Prairie Island Independent Spent Fuel Storage Installation
Docket 72-10
Renewed Materials License No. SNM-2506

Response to Request for Additional Information: License Amendment Request to Expand the Storage Capacity of the Independent Spent Fuel Storage Installation (ISFSI) (EPID No. L-2019-LLA-0169)

Response to Request for Additional Information

License Amendment Request to Expand the Storage Capacity of the Independent Spent Fuel Storage Installation (ISFSI)

Figure 2.1: Soil Liquefaction Factor of Safety from CPT and SPT data

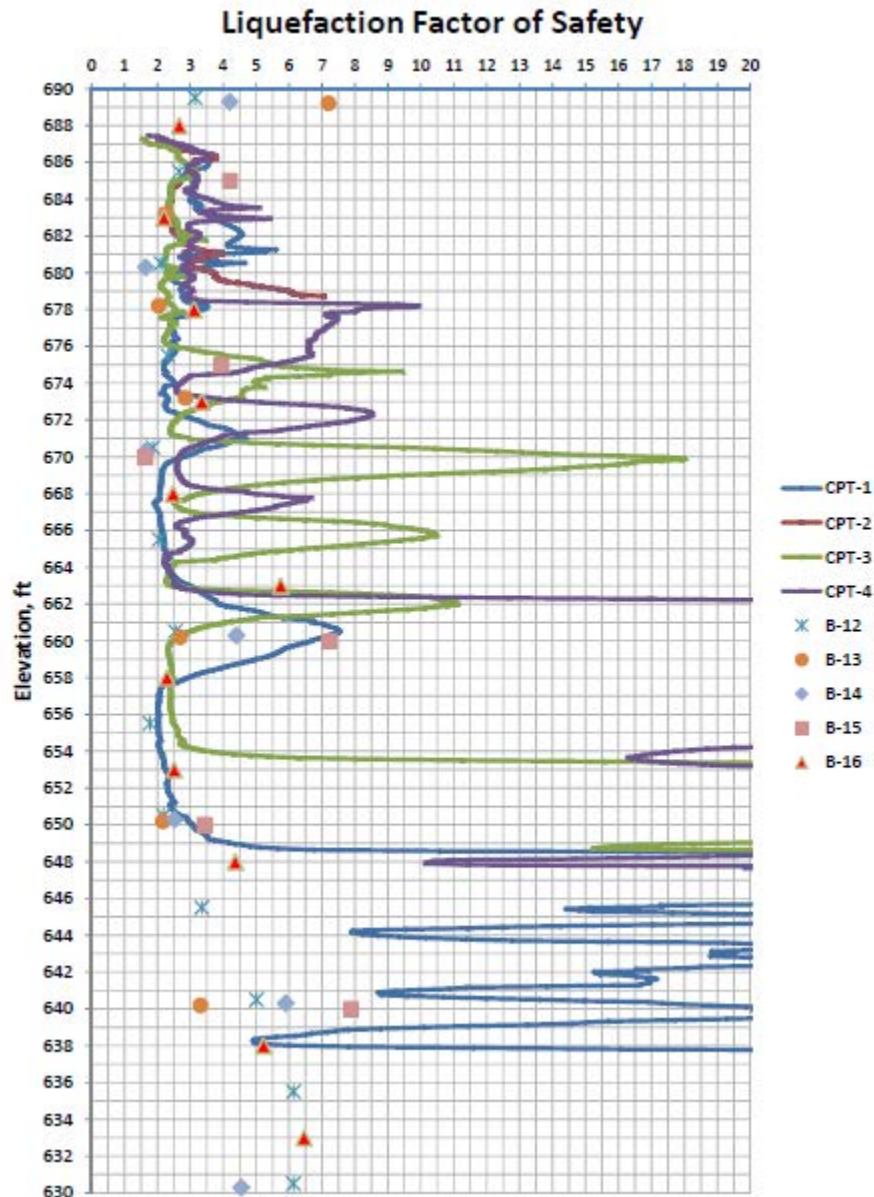
- c. Provide the values of Cyclic Resistance Ratio (CRR) and Cyclic Stress Ratio (CSR) and/or Factors of Safety (FS) in graphical or tabular form for the depths of study as related to the proposed ISFSI pad. Also provide a calculation package or sample calculations describing the efforts made for this analysis. In Section 3.2.2 of the submittal, the applicant states “the ratio of the shear resistance (CRR) of the soil under repetitive loading to earthquake-induced shear stresses (CSR) at various depths was calculated using both the CPT and SPT data.” The staff cannot determine how the current CPT and SPT data correlate.

For numerical analysis of the soil liquefaction potential of the new ISFSI pad site, detailed calculations were performed for the site. A numerical analysis establishes the factor of safety ($FS = CRR/CSR$) against liquefaction for the sites. The ratio of the shear resistance (CRR) of the soil under repetitive loading to earthquake-induced shear stresses (CSR) at various depths is calculated using both CPT and SPT data. Calculation of CRR and CSR, and the liquefaction

evaluation using the resulting FS, follows the procedures described in Regulatory Guide (RG) 1.198, "Procedures and Criteria for Assessing Seismic Soil Liquefaction at Nuclear Power Plant Sites" (Reference 3), and NUREG/CR-5741, "Technical Bases for Regulatory Guide for Soil Liquefaction" (Reference 4). A detailed calculation was performed following a procedure by Youd, T.L., Idriss, I.M., et al. (Reference 5), which is referenced by RG 1.198.

Figure 2.1 provides FS values at various depths of the site for both CPT and SPT data.

Figure 2.2: Artificial (Synthetic) Acceleration Time-History, Horizontal H1

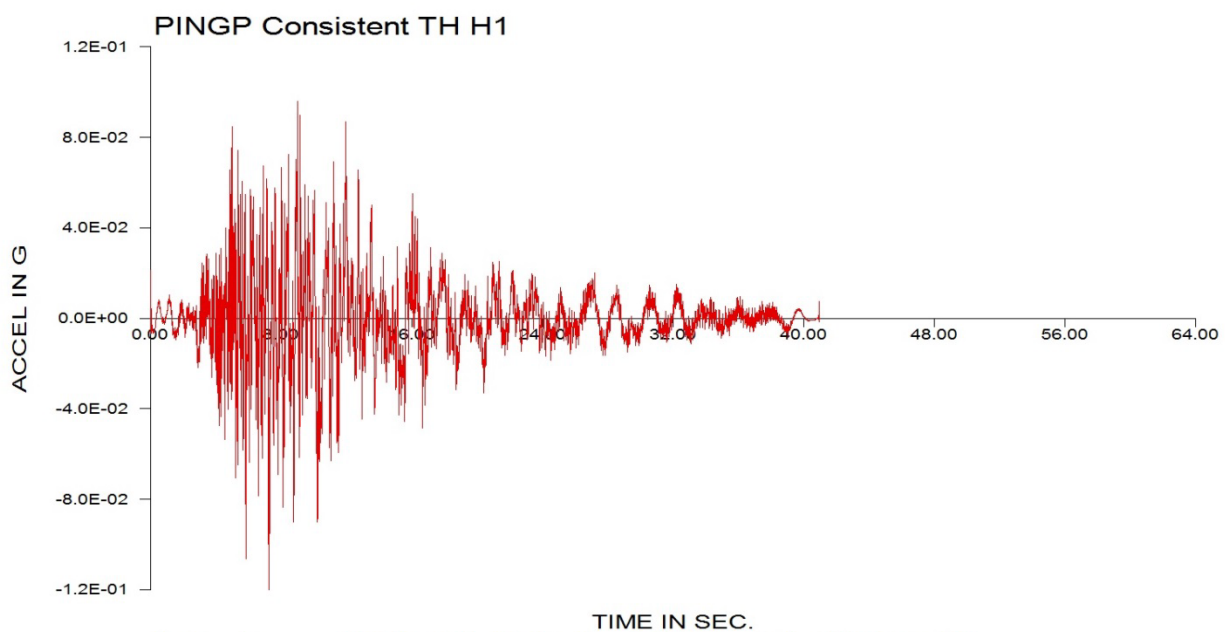
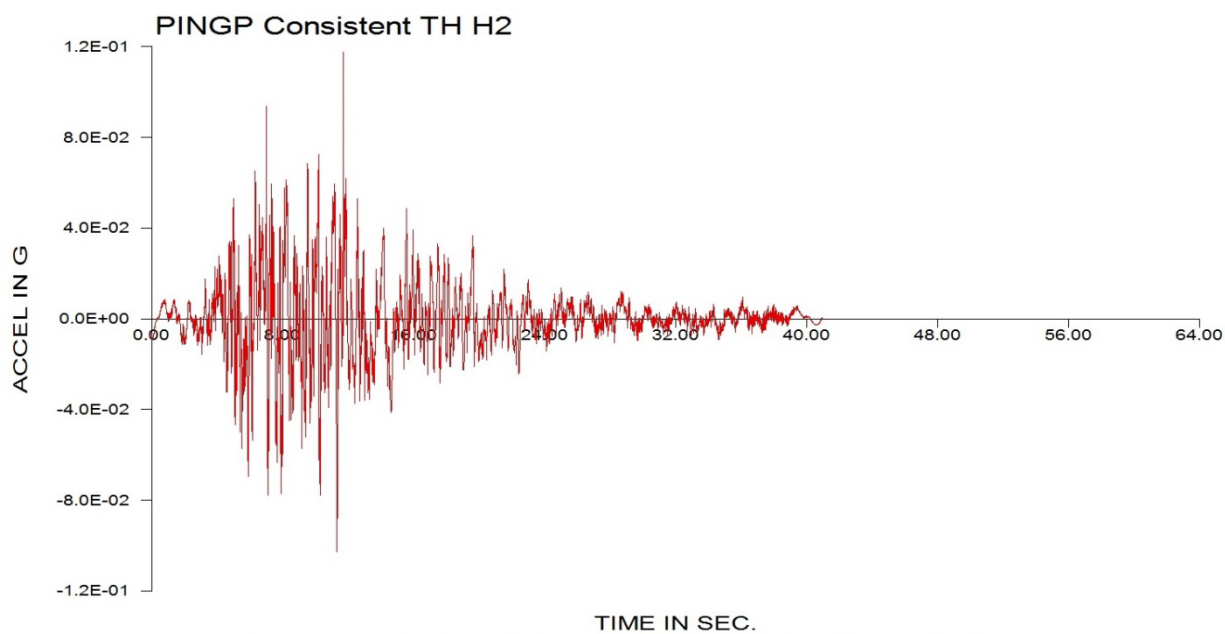
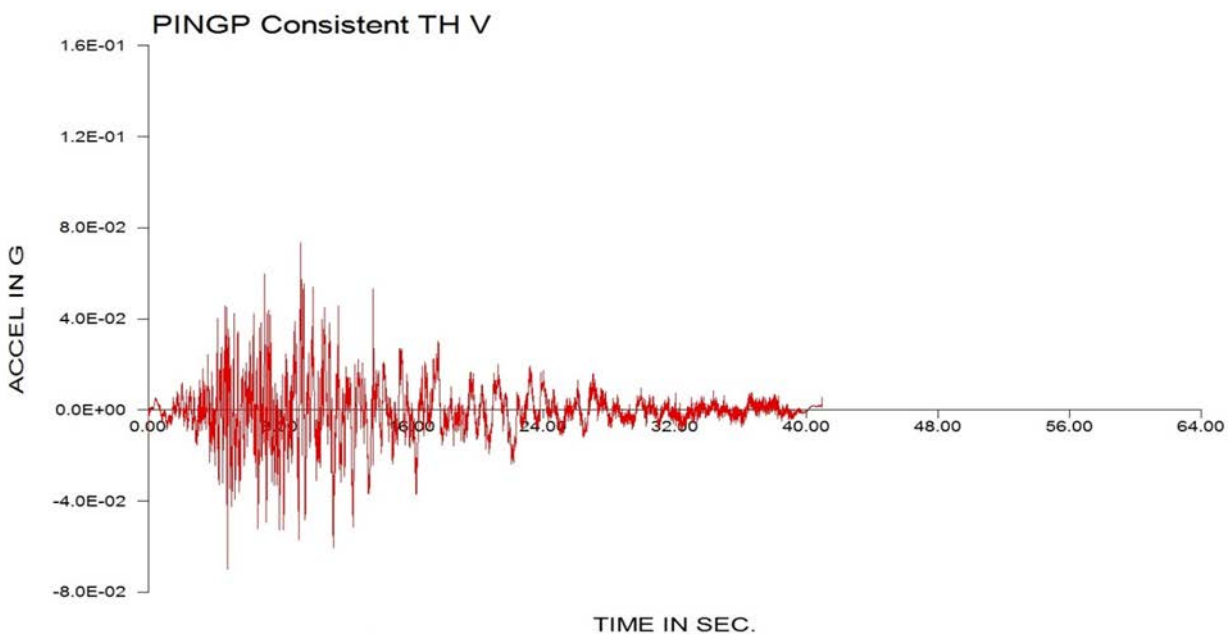
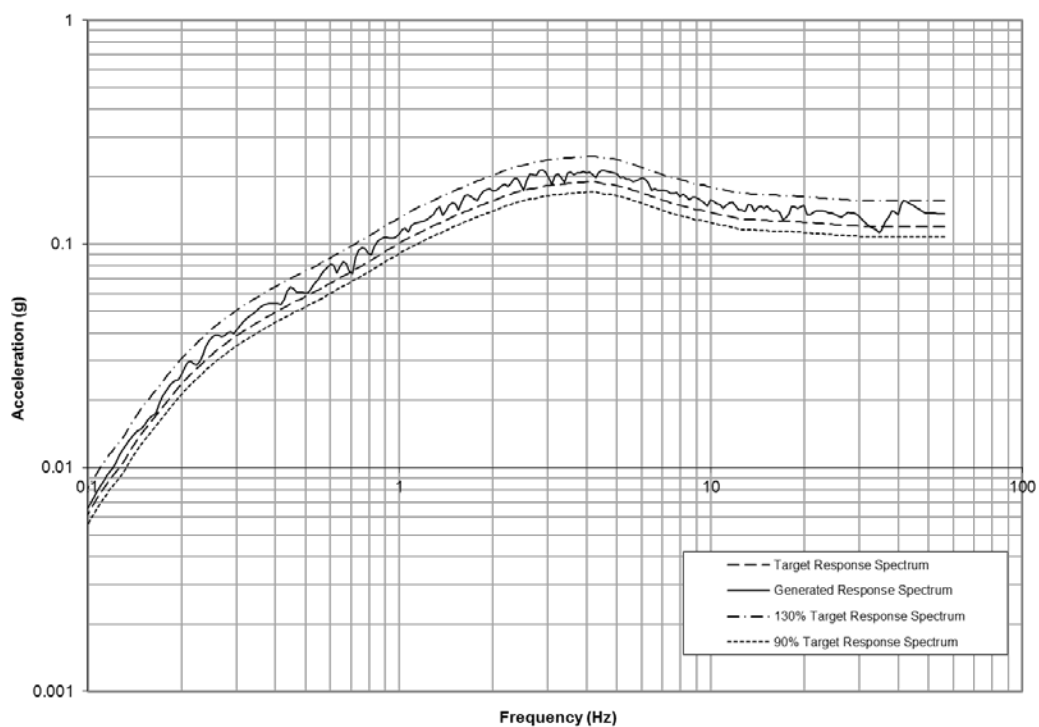
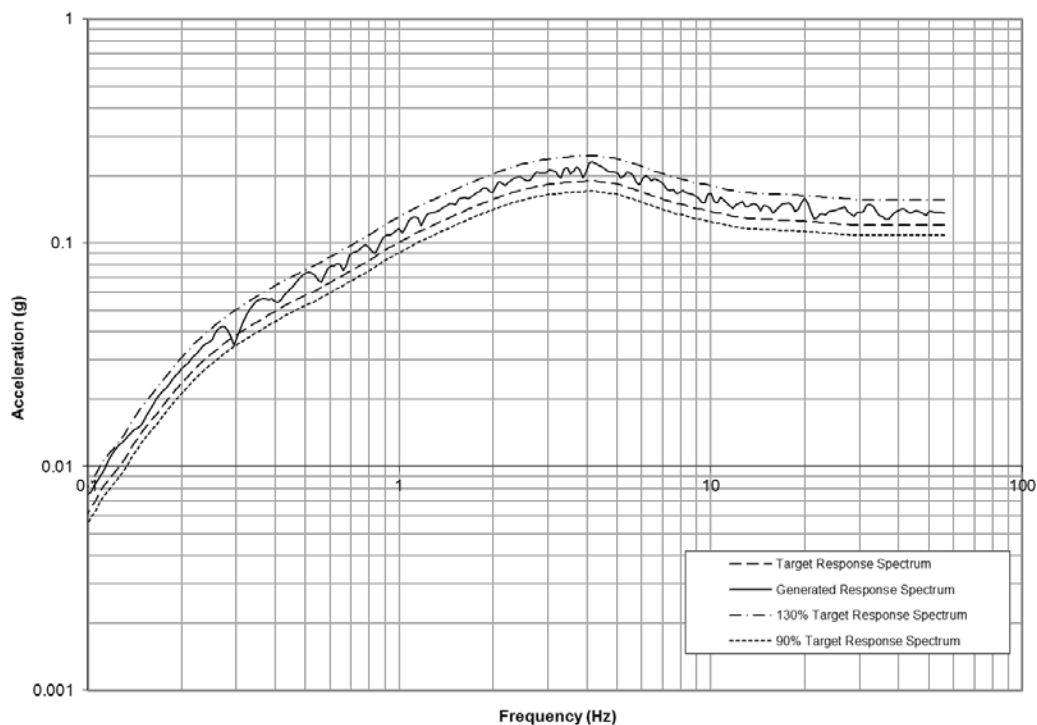
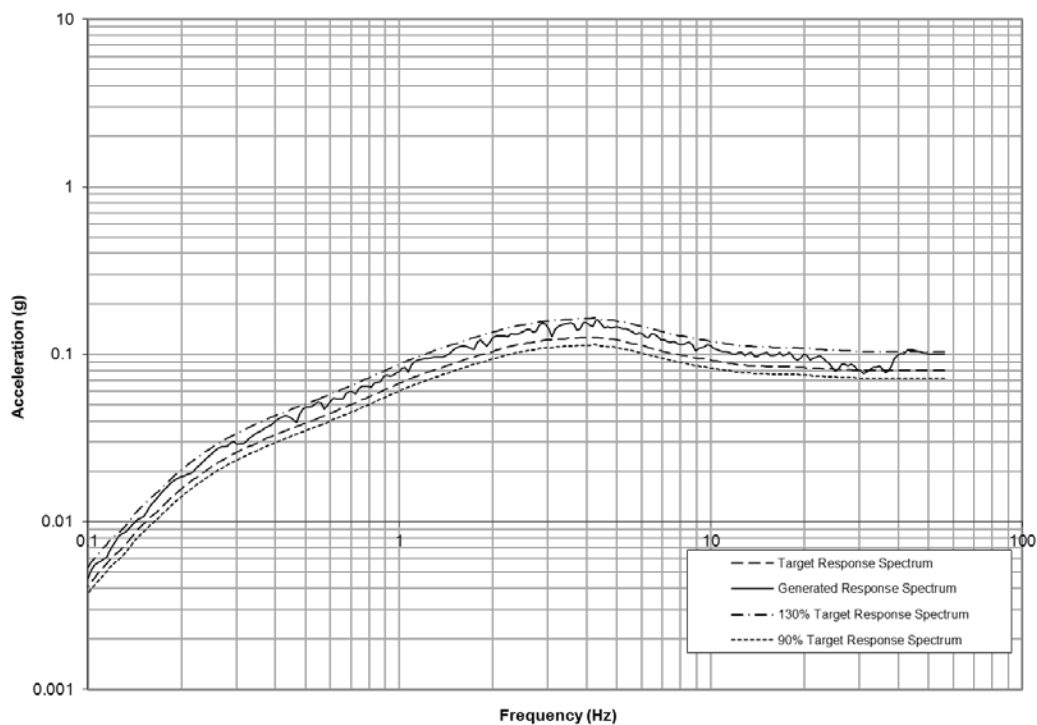
- a. Provide the Acceleration Input Motions generated per Approach 2, Option 1 of NUREG 0800, Chapter 3.7.1.
- b. Provide the Upper Bound, Best estimate and Lower Bound strain compatible soil properties (shear modulus and damping) data per depth generated for the SSI analysis in graphical or tabular form.
- c. Justify why Model 3 for the single cask on the corner of the pad is the governing loading case.
- d. Provide a schematic of the ISFSI pad model used for SASSI2010 analysis including mesh distribution and sizes.
- e. Provide results of the 36 SSI analysis cases analyzed in tabular format, as appropriate.

To perform soil-structure interaction analysis, artificial acceleration input motions that are consistent with the design input response spectra were developed following NUREG-0800, Chapter 3.7.1. The generated acceleration input motions are shown in Figures 2.2 through Figures 2.4 and acceleration response spectra comparisons are shown in Figures 2.5 through 2.7. The generated acceleration input motions also meet the requirements for the strong motion duration, the absolute values of correlation coefficient, the energy gap for the frequency range of interests, and the phase angle consistency.

Figure 2.14: Finite Element Analysis Mesh

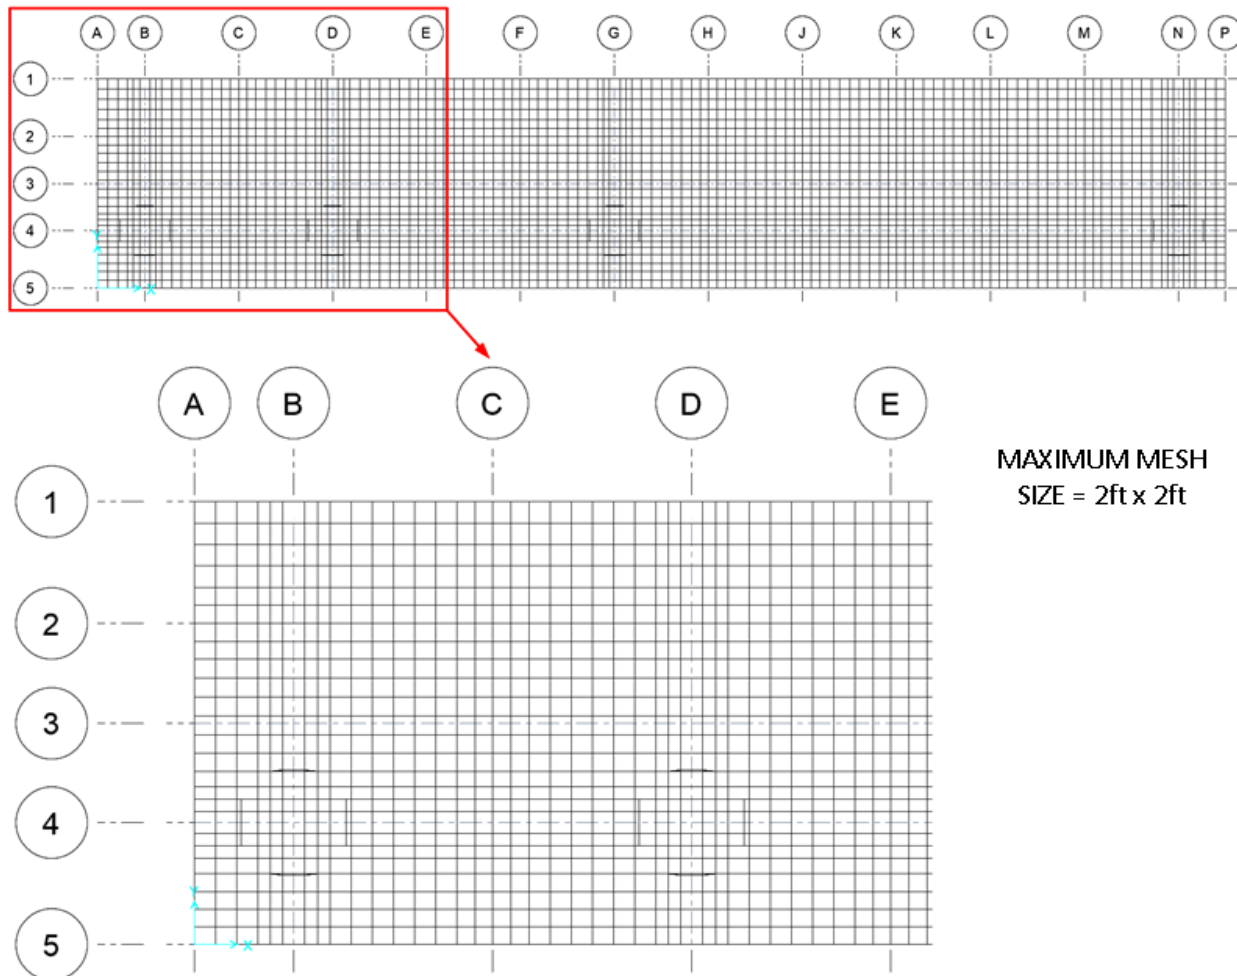
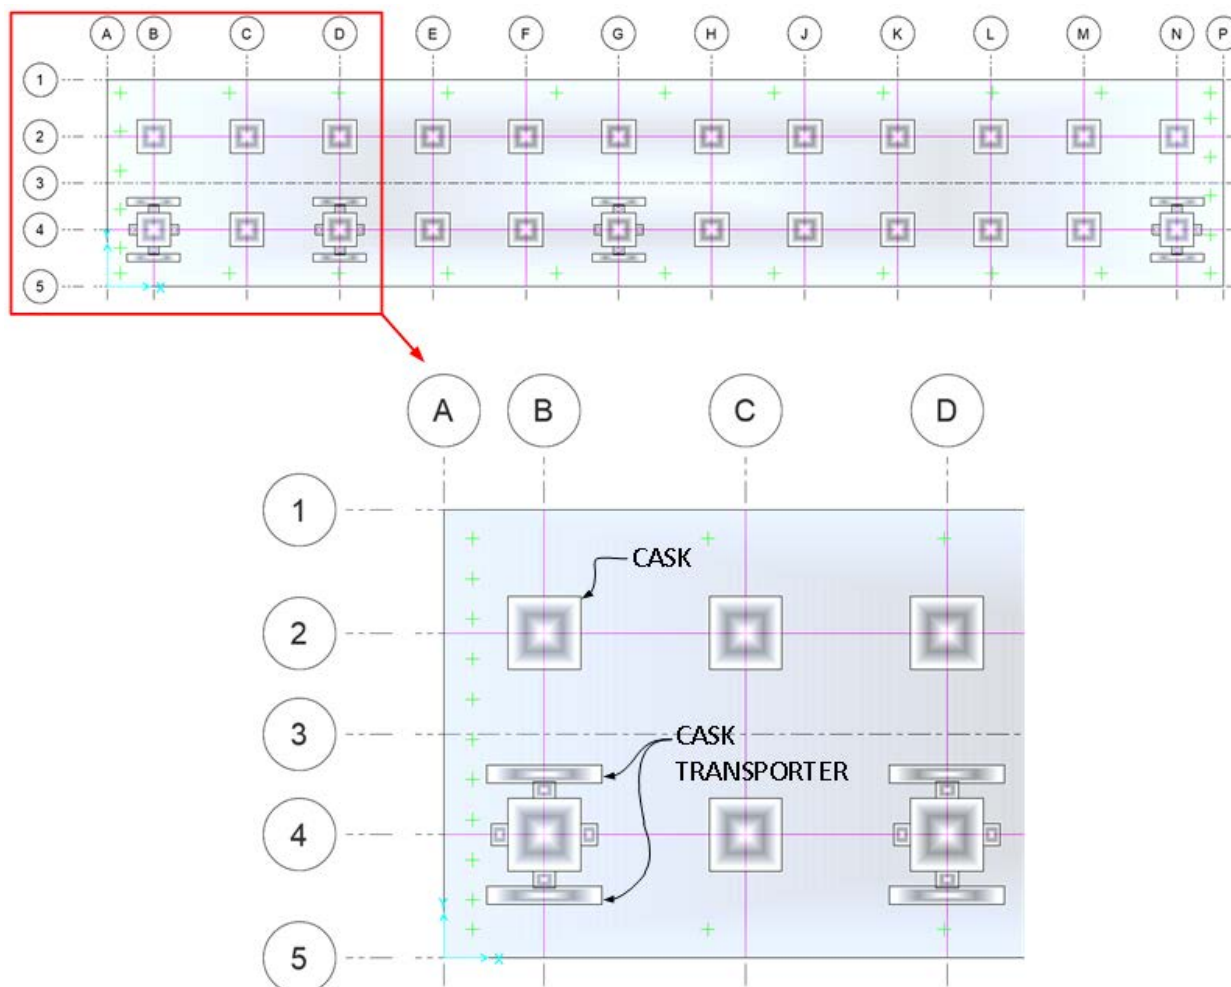
Provide additional structural analysis details.

The finite element mesh and cask locations on the pad are provided Figures 2.14 and 2.15.
